**Report Type:** DA Access Report  
**Reference Number:** 19210  
**Client:** DKO  
**Site Address:** 28 Lockwood Avenue, Belrose NSW

# ACCESS REPORT

This Access Compliance Report is to accompany a Development Application for the development proposed at 28 Lockwood Avenue, Belrose NSW.

**Basement 3 showing 5 accessible parking spaces allocated to the residential portion of the development.**

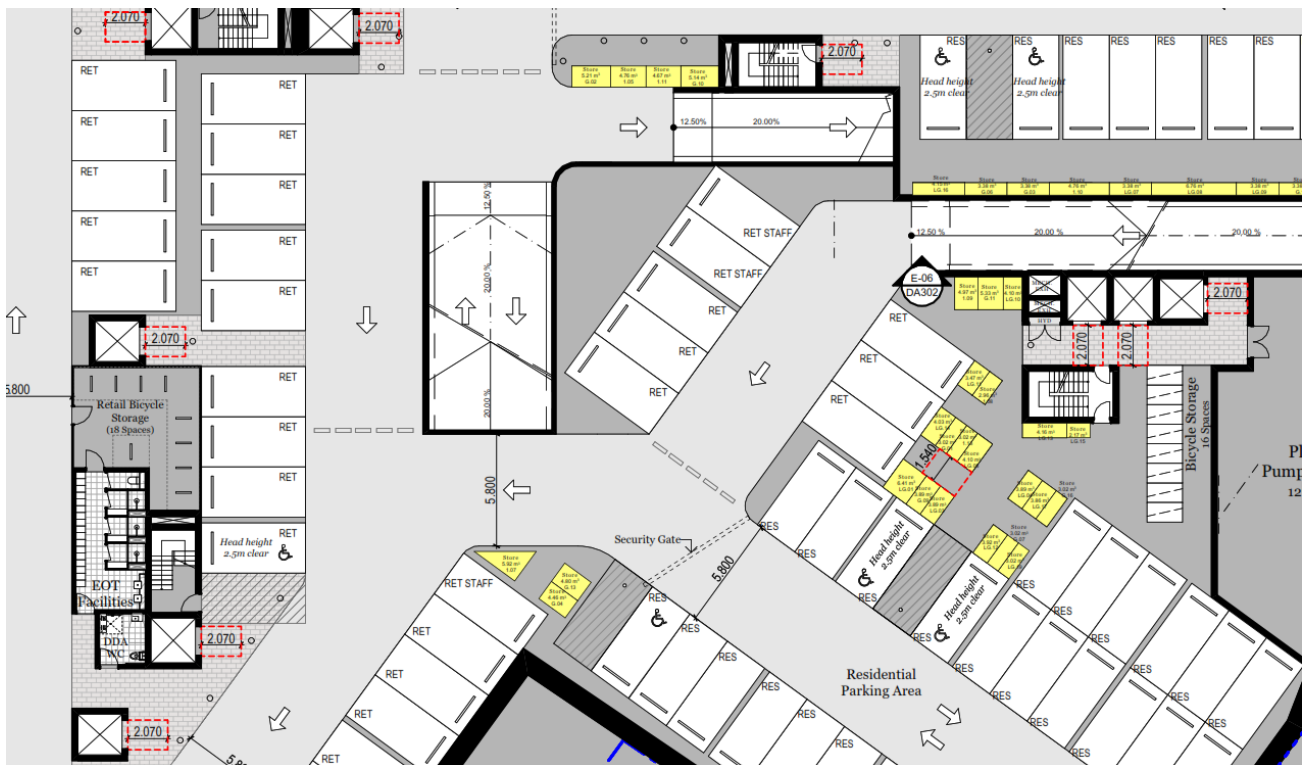
<b>BCA Part D3.5 Accessible Carparking</b>
<b>Requirement</b>	<b>Class 2</b> There are no Accessible carparking requirements for a Class 2 under the BCA. If adaptable housing has been mandated by the Council, then carparking spaces for Adaptable units will be required under the requirements of AS4299- Adaptable housing.
<b>Compliance Comments</b>	Complies Northern Beaches Council requires provision of 10% Adaptable units in the development. Development has total number of 49 units. 10% of 49 = 5 required Adaptable units. Therefore, 5 accessible / AS4299 compliant carparking spaces are required / provided for the residential component of the development. One accessible compliant parking space is required to be allocated to each of the Adaptable units. Detailed features of the accessible/ adaptable parking spaces are to be verified at CC stage of works.
